**RE: SHERWOOD FOREST ~ LOT 646
646 Maid Marion Hill
Annapolis MD, 21405
Variance Application**

VARIANCE PLAN
SHERWOOD FOREST ~ LOT 646
646 MAID MARION HILL, ANNAPOLIS, MARYLAND 21405
TAX MAP 0039 GRID 0019 PARCEL 0295 DISTRICT 2ND
ANNE ARUNDEL COUNTY, MARYLAND

CONFIRMATION OF PRE-FILE

PRE-FILE #: 2025-0070-P
DATE: 07/31/2025
OPZ STAFF: David Russell
Stacy Poulos
Jean Janvier
Kelly Krinetz

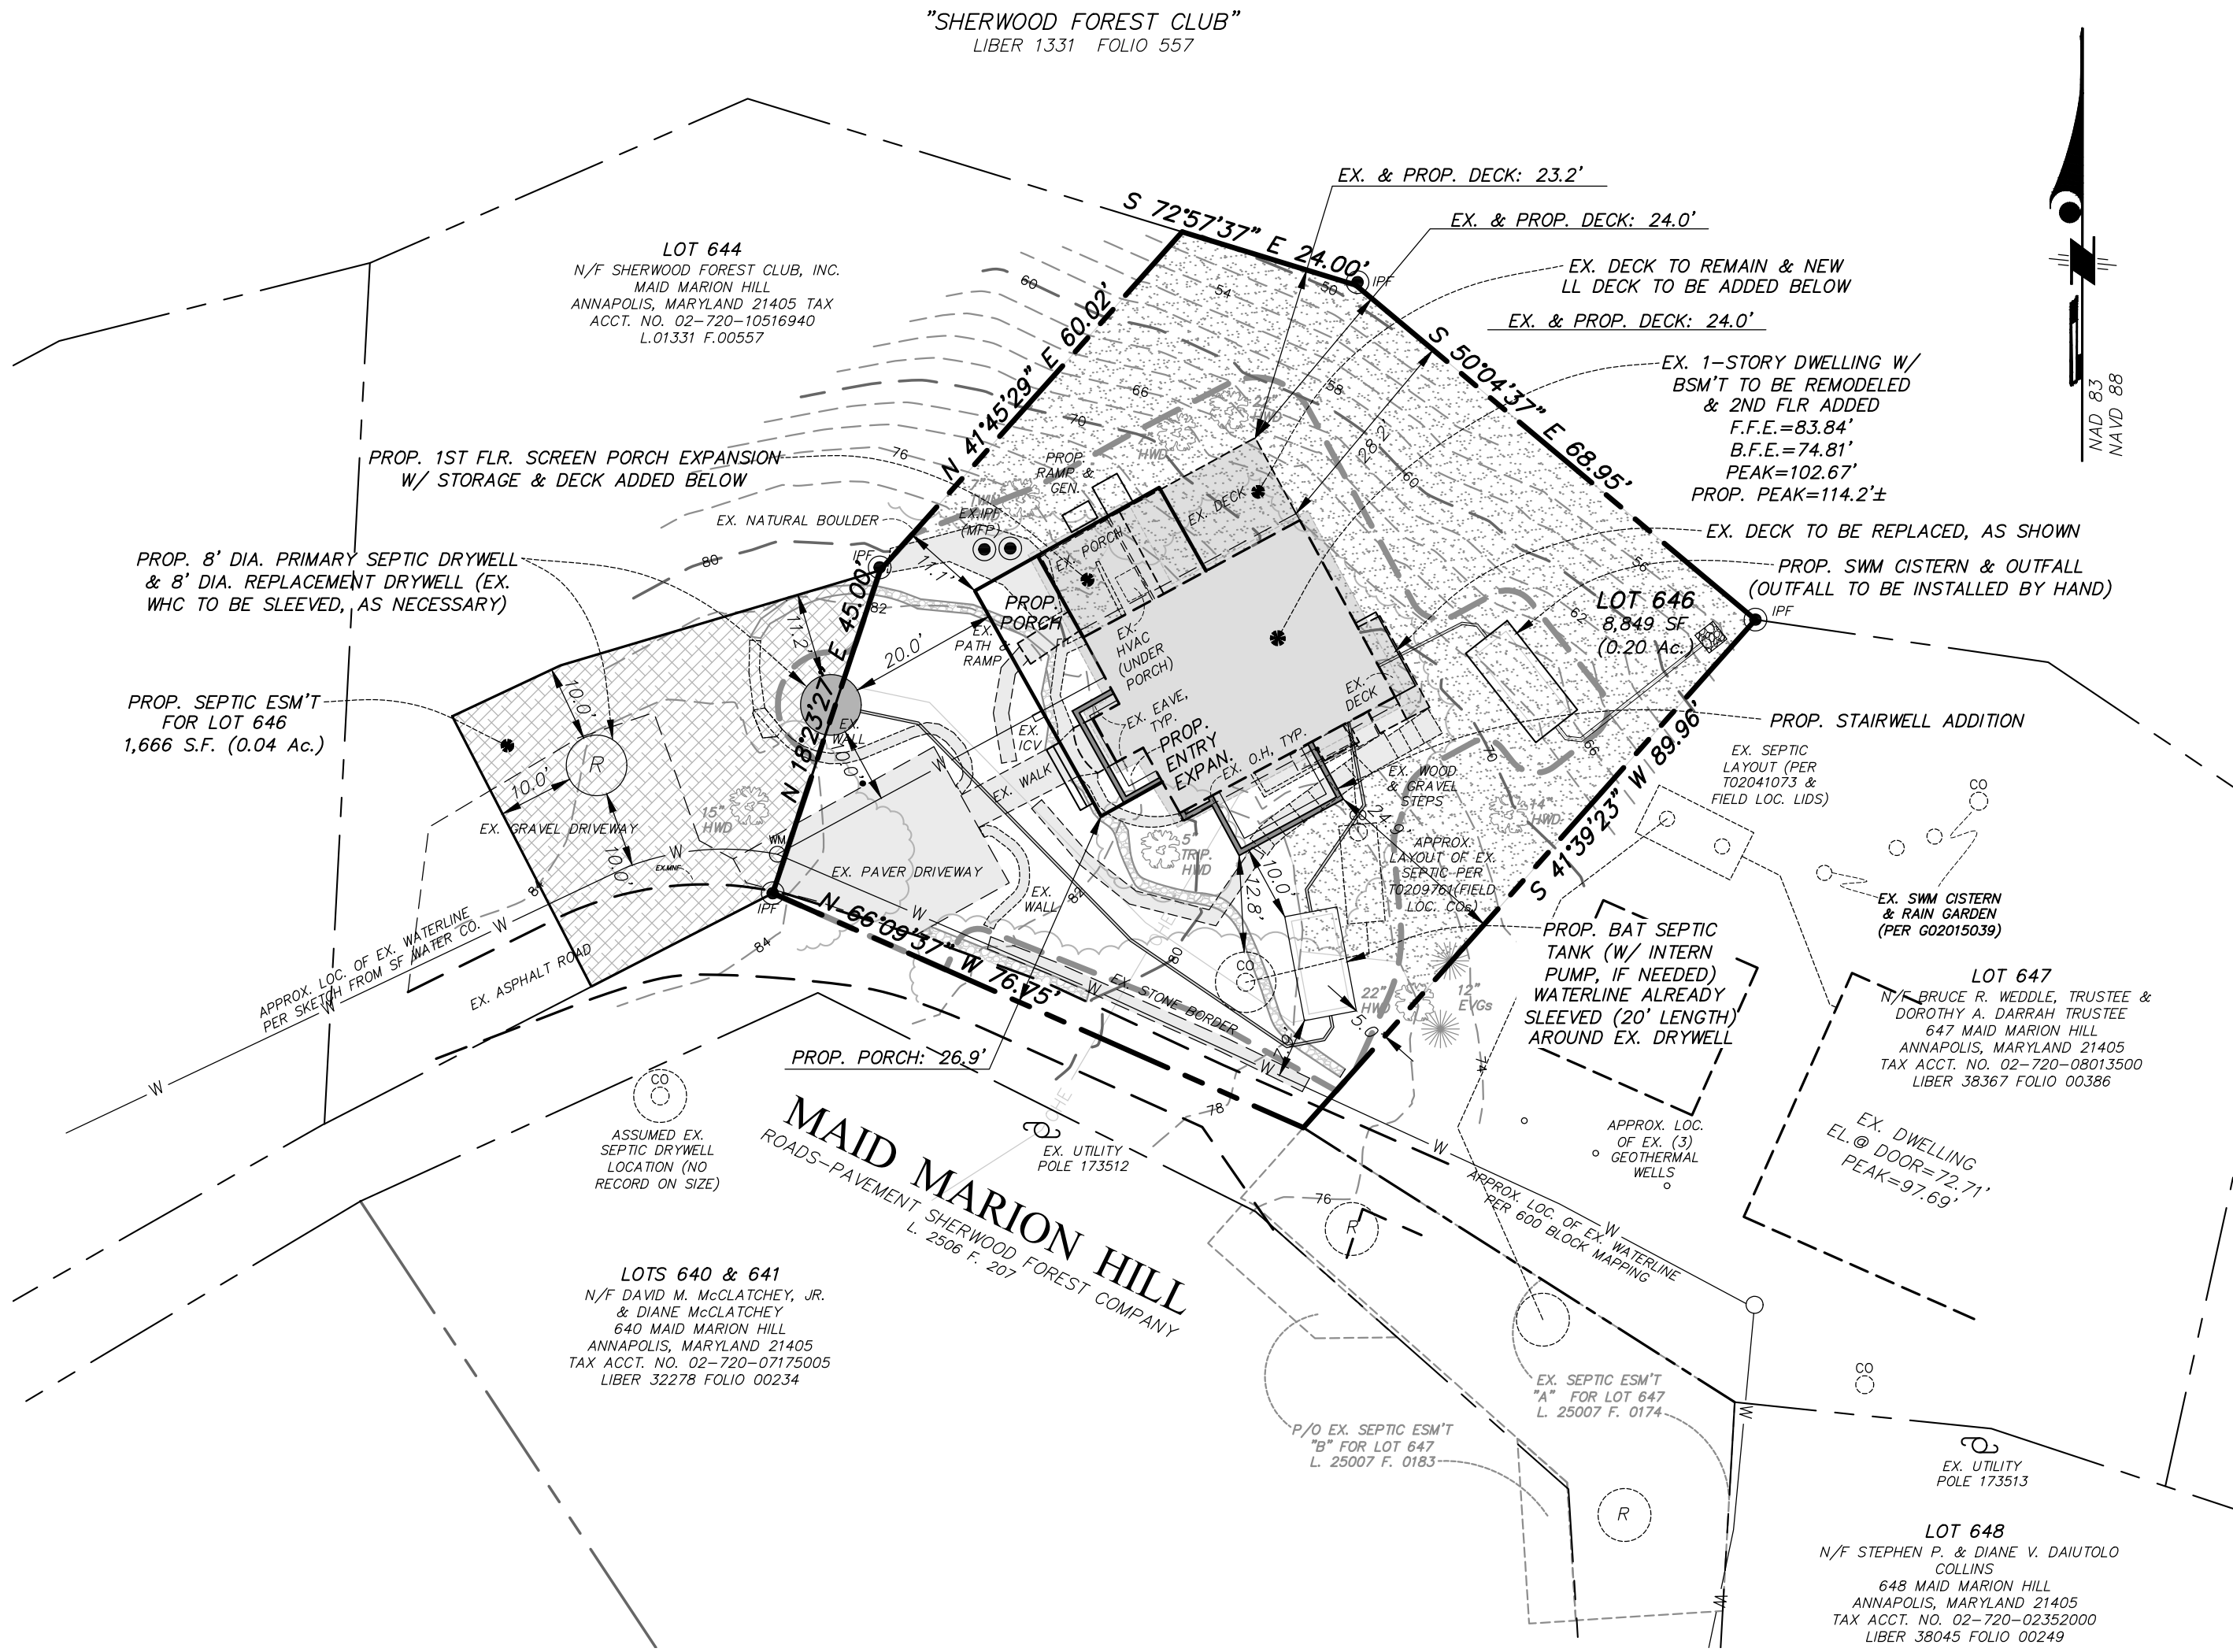
1. Show the LOD on the Site Plan.
2. The current proposed cistern location meets setback to the proposed BAT septic tank, but not the existing septic tank on the adjacent property.
3. The proposed BAT septic tank must be a minimum of 10 feet from the existing water line.
4. The existing Sherwood Forest community water line runs through this property. Show the easements for this water line and ensure all its required setbacks are met.
5. The proposed stormwater rain garden must be a minimum of 7.5 feet from the community water line and any associated utility easement.
6. Show the lawn area where the water collected in the rainwater cisterns will be used for irrigation or watering of the property. This can be done at grading permit.
